PG&E Letter DCL-22-018  
PG&E Letter DIL-22-007

Diablo Canyon Units 1 and 2  
Docket No. 50-275, OL-DPR-80  
Docket No. 50-323, OL-DPR-82  
Docket No. 72-26, Materials License No. SNM-2511  
Diablo Canyon Independent Spent Fuel Storage Installation  
Responses to NRC Requests for Additional Information on “License Amendment Request 21-04, Proposed Changes to the Diablo Canyon Power Plant Emergency Plan for Post-Shutdown and Permanently Defueled Condition”

**Responses to NRC Request for additional information – Diablo Canyon proposed changes to emergency plan for post-shutdown and permanently defueled condition (EPID: L-2021-LLA-0190)**

5.22 FIGURE 5-2, TSC ORGANIZATION

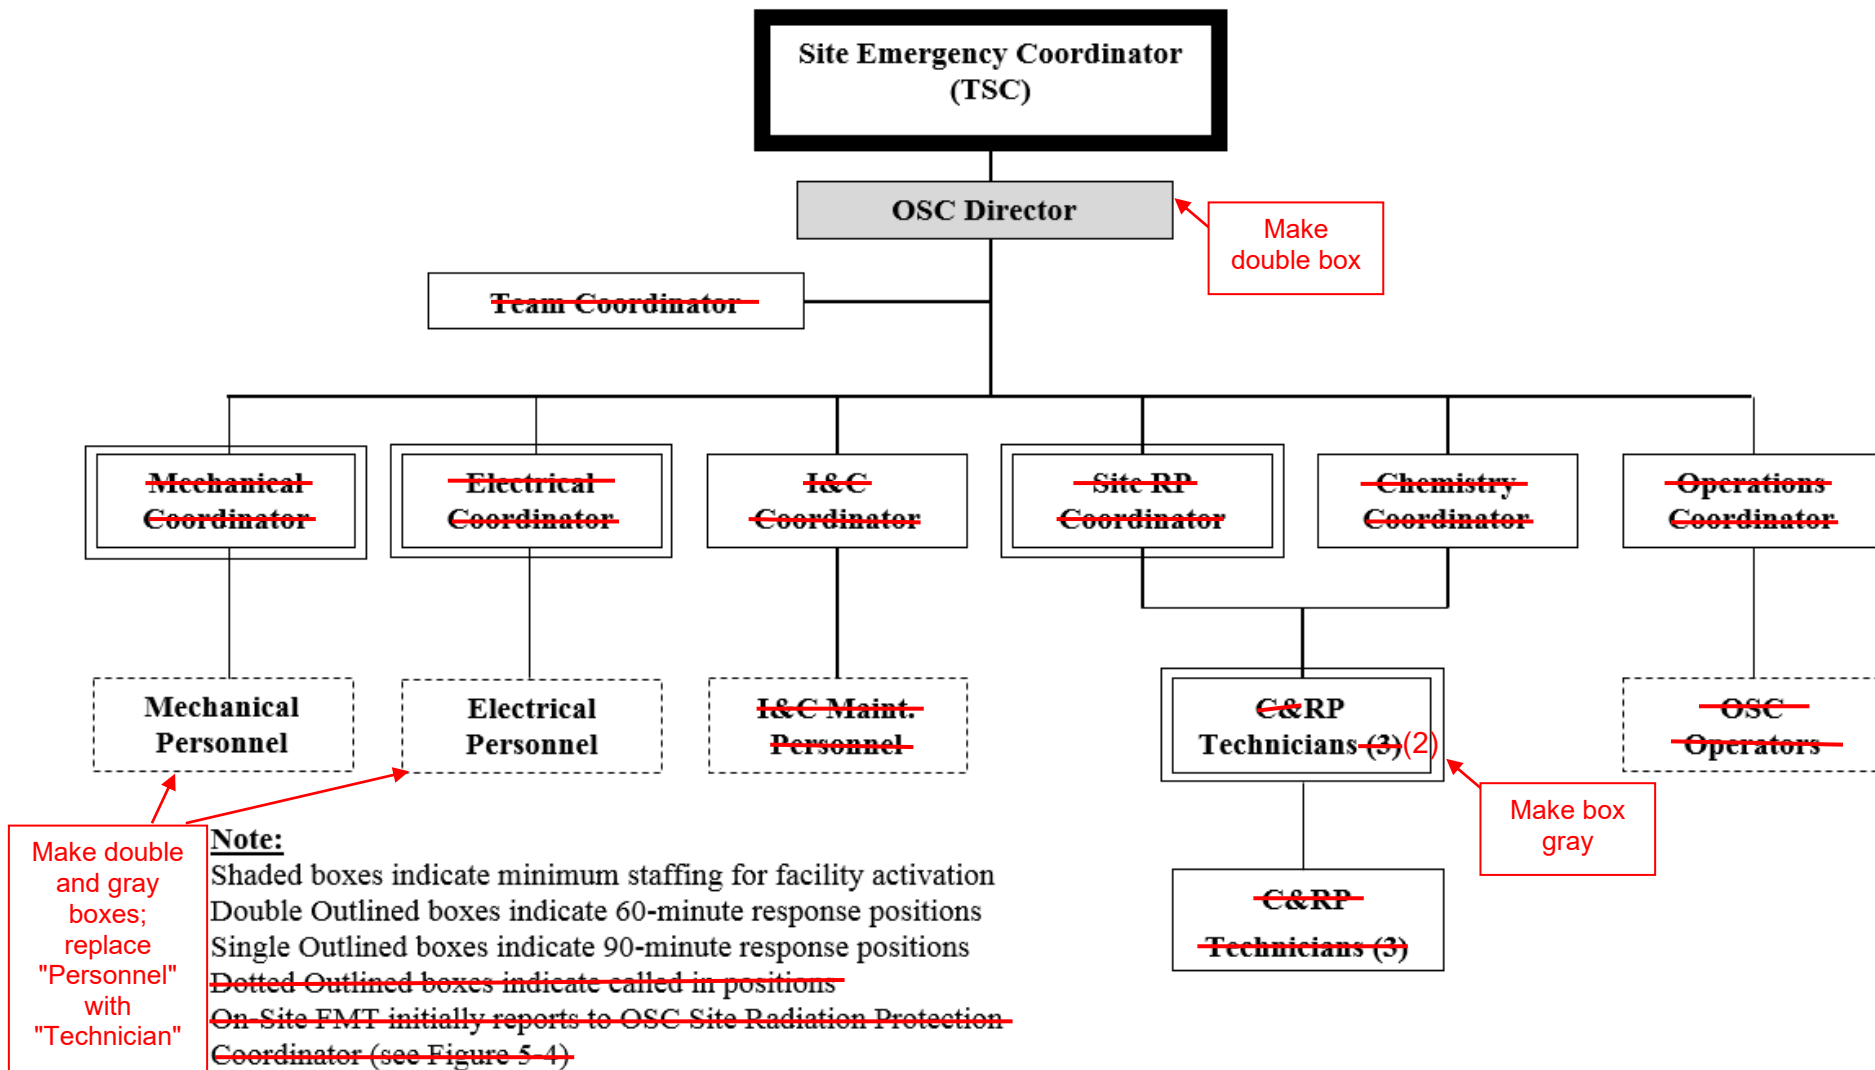
*The PG&E analysis of the proposed post-shutdown On-Shift and Augmented ERO Staffing Assessment concluded that in a permanently defueled condition, the TSC [Technical Support Center] Engineering Advisor will be qualified to provide engineering support in response to a Fuel Handling Accident (FHA) in the fuel handling building or an event resulting in damage to the Spent Fuel Pool (SFP) integrity or loss of SFP cooling or inventory. As a result of this analysis, PG&E proposed that the TSC Engineering Advisor would assume the functions of engineering support and therefore, has proposed to eliminate both the currently approved Mechanical and Electrical Engineering 60-minute response positions and replacing those emergency positions with a proposed 90-minute response position of a TSC Engineering Advisor. [emphasis added]*

*As proposed, the minimum engineering staffing will not allow the facilities to perform the intended functions within 60 minutes (e.g., Plant System Engineering is provided by the TSC Engineering Advisor with a 90-minute response).*

*Describe how the augmented engineering staffing will continue to be aligned with the current DCPD E-Plan to ensure the continued effective and timely implementation of the major task of Technical Support/Accident Analysis within 60 minutes of the declaration of an Alert or higher ECL.*

To ensure the continued effective and timely implementation of the major task of Technical Support/Accident Analysis, the proposed Diablo Canyon Power Plant (DCPP) Emergency Plan (E-Plan) is revised to designate the Technical Support Center (TSC) Engineering Advisor as a minimum staff 60-minute responder (i.e., within 60 minutes of the declaration of an Alert or higher emergency classification level [ECL]).

Qualifications for the TSC Engineering Advisor position selection criteria will align with the current position requirements. As discussed in Enclosure 1, Section 5.2.5a of the license amendment request, the Attachment 4 Task Analysis concluded that all of the TSC Engineers' responsibilities and tasks can be eliminated. As such, no new tasks are being added to the TSC Engineering Advisor position and the Engineering function will continue to be maintained by the TSC Engineering Advisor without competing priorities. Revised DCPP E-Plan, Sections 5.19 and 5.22, markup and clean pages are provided in the Attachments of this Enclosure to reflect this change.

5.23 FIGURE 5-3, OSC ORGANIZATION

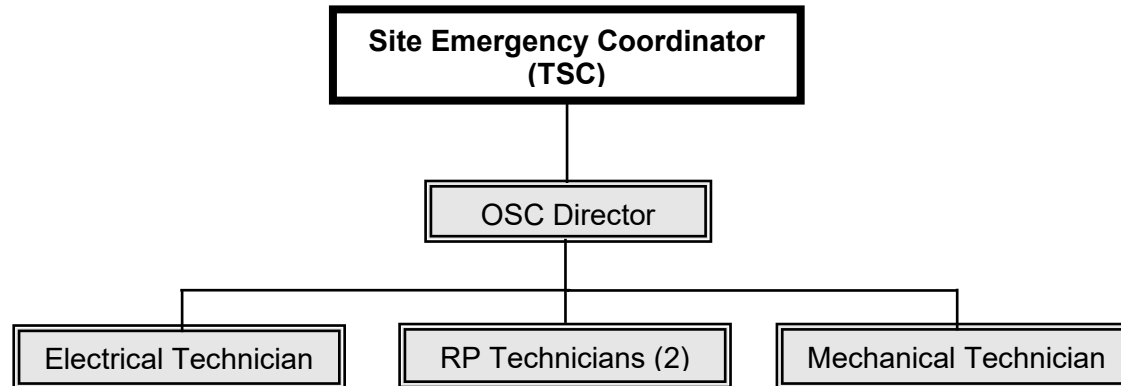
*The PG&E analysis of the proposed post-shutdown On-Shift and Augmented ERO Staffing Assessment concluded that in a permanently defueled condition, the OSC [Operations Support Center] Director would assume the function of repair and corrective actions (e.g., Mechanical and Electrical Maintenance) as a 90-minute responder. As a result of the OSC Director assuming these functions, the OSC Mechanical and Electrical Maintenance Coordinators would be eliminated as 60-minute responders from the currently approved DCPP E-Plan. [emphasis added]*

*As proposed, the minimum maintenance staffing will not allow the facilities to perform the intended functions within 60 minutes (e.g., maintenance support is provided by the OSC Director with a 90-minute response with Mechanical Maintenance and Electrical/Instrumentation and Controls (I&C) Maintenance positions called-in as needed to support repair and corrective actions).*

*Describe how the augmented maintenance staffing will continue to be aligned with the current DCPP E-Plan to ensure the continued effective and timely implementation of the major task of Repair and Corrective Actions within 60 minutes of the declaration of an Alert or higher ECL.*

To ensure the continued effective and timely implementation of the major task of Repair and Corrective Actions, the proposed DCPP E-Plan is revised to maintain the Operations Support Center (OSC) Director as a minimum staff 60-minute responder (i.e., within 60 minutes of the declaration of an Alert or higher ECL). In addition, one qualified Mechanical Maintenance technician and one qualified Electrical Maintenance technician will be minimum staff 60-minute OSC responders. Revised DCPP E-Plan, Sections 5.7.3, 5.19, 5.20, and 5.23, markup and clean pages are provided in the Attachments of this Enclosure to reflect these changes.
